Technical Service Bulletin

Subject: DRIVER AND/OR PASSENGER SEAT WARMER(S) INOPERATIVE - (CLOTH SEATS ONLY)	Bulletin No.: 09-017/18
	Last Issued: 04/27/2018

2013-2016 CX-5 vehicles equipped with cloth seats

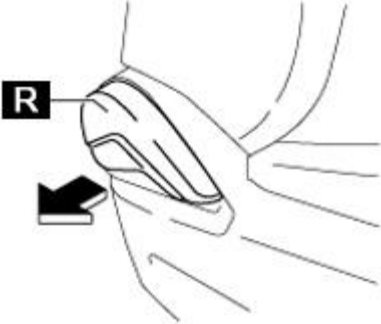
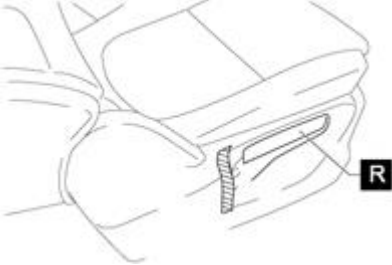
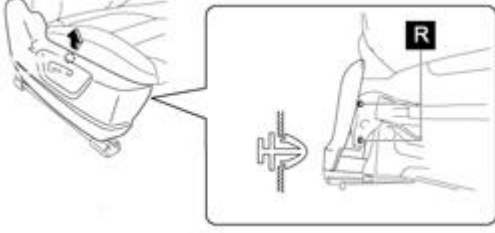
Some vehicles may exhibit inoperative driver and/or front passenger side seat warmer(s) in any mode (High, Mid and Low). This may be caused by repeated load applied to the seat cushion (1) while the seat is occupied. A section of the heater mat (2) just above the reinforcement rod (3) in the cushion pad contacts internal heater mat wire and causes damage (4).

- A new seat cushion pad is available with a repositioned internal heater mat wire to prevent contact with the reinforcement rod.
- **2016 CX-5: There is no modified seat cushion available for the front passenger side seat, only the driver's side seat cushion is available.**
